## Chapter 2: Changes to the Draft EIS

This section provides the changes by section to the Draft EIS. The changes are identified with underline indicating new text and strikeout for those portions of the Draft EIS that have been revised in response to comments received from the public and state and federal regulatory agencies.

**Figure 4.4—Proposed Drainage System Improvements.**

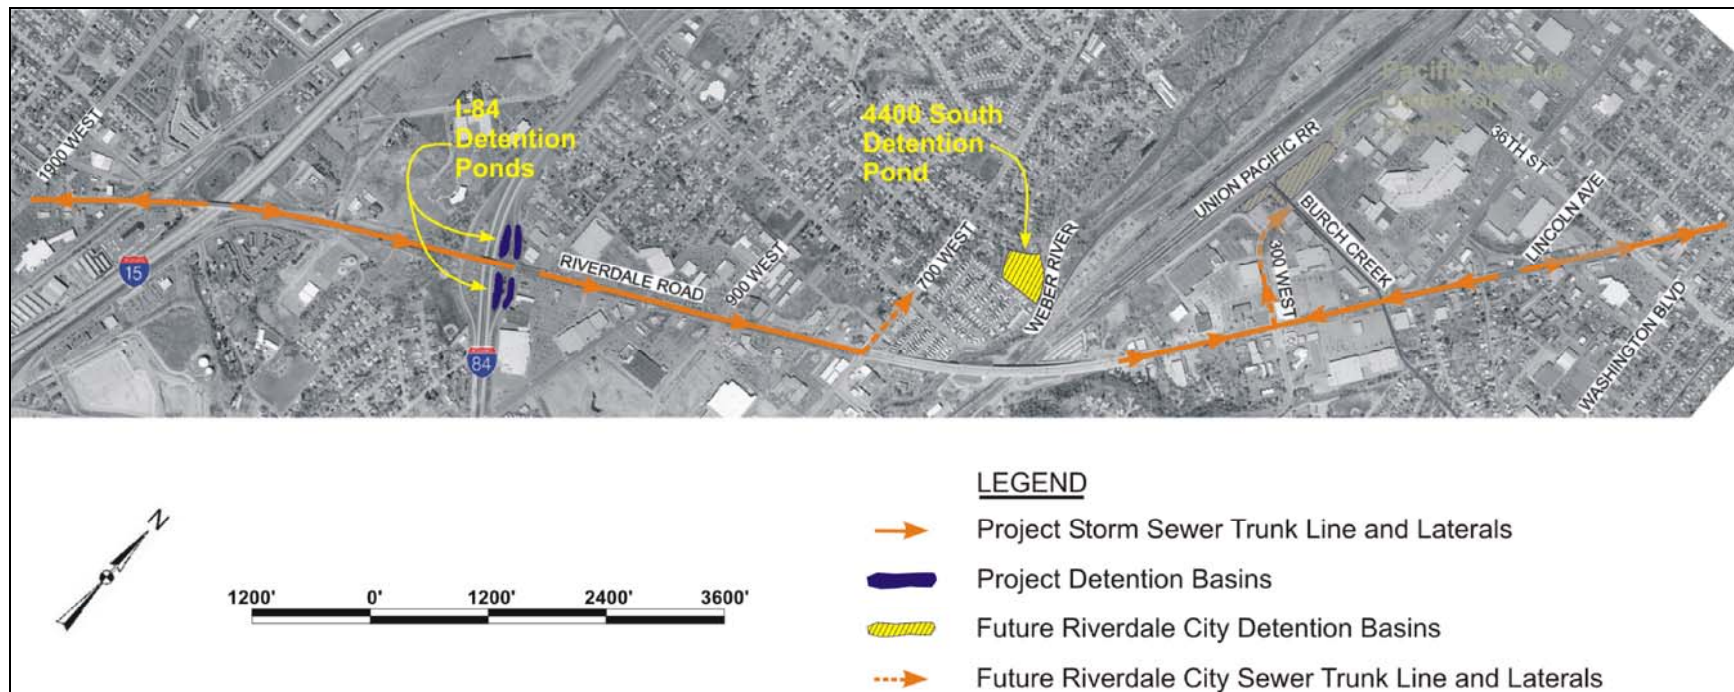
The proposed drainage infrastructure features six subsystems (shown in Figure 4.4) and would outfall to a new detention basin, a new proposed city storm sewer, or an existing trunk line of another storm sewer. These subsystems along Riverdale Road are as follows:

The Weber River to Burch Creek subsystem also lies within Riverdale. Runoff would be conveyed to the north through a new outfall pipe along 300 West and Pacific Avenue to Burch Creek. ~~A detention basin would be constructed along the west side of Pacific Avenue. This basin, which is about 12.3 acre feet in size, would restrict the outflow to Burch Creek. The 300 West outfall and Pacific Avenue detention pond would be constructed by Riverdale City as an independent project.~~

The Lincoln Avenue to Burch Creek subsystem would connect to the 300 West outfall. The storm sewer trunkline in Riverdale Road would be constructed as part of this project. All runoff within this area would drain the 300 West outfall and into ~~the proposed detention basin at Pacific Avenue~~ Burch Creek.
